Subject: Description of Permissive Change

FCC ID: 2A2JJYE650ARS

Model Name: YE650AR

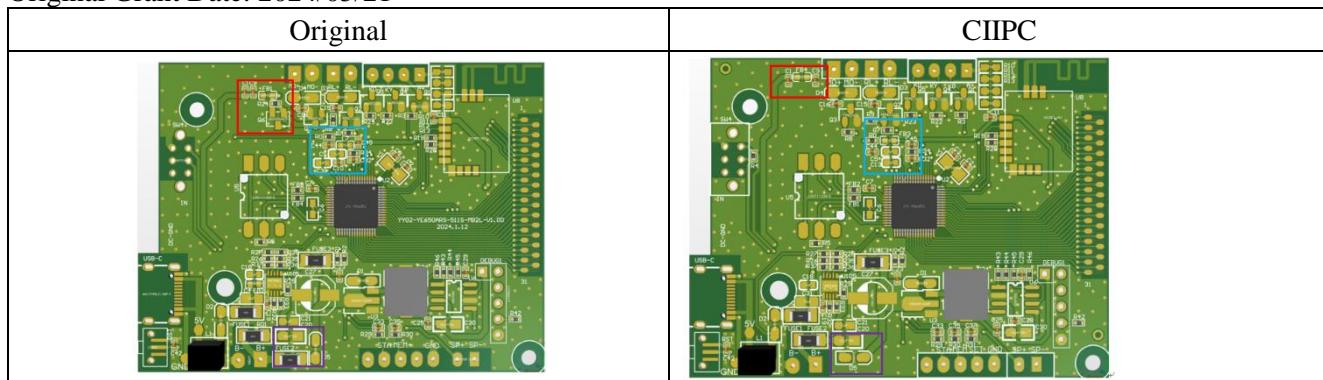
1. The red part modifies the air pump control circuit and component layout, the blue part modifies the layout of microcontroller peripheral devices, the purple part modifies the fuse position and removes a $0\ \Omega$ resistor.
2. YE650AR IP classification is changed from IP20 to IP21, and its structure is adjusted as follows: reduced 0.45mm thickness for top cover buttons, and a 0.45mm thick, 2mm wide foam has been added to the panel button area.
3. Change the tested model from "YE650ARS" to "YE650AR".
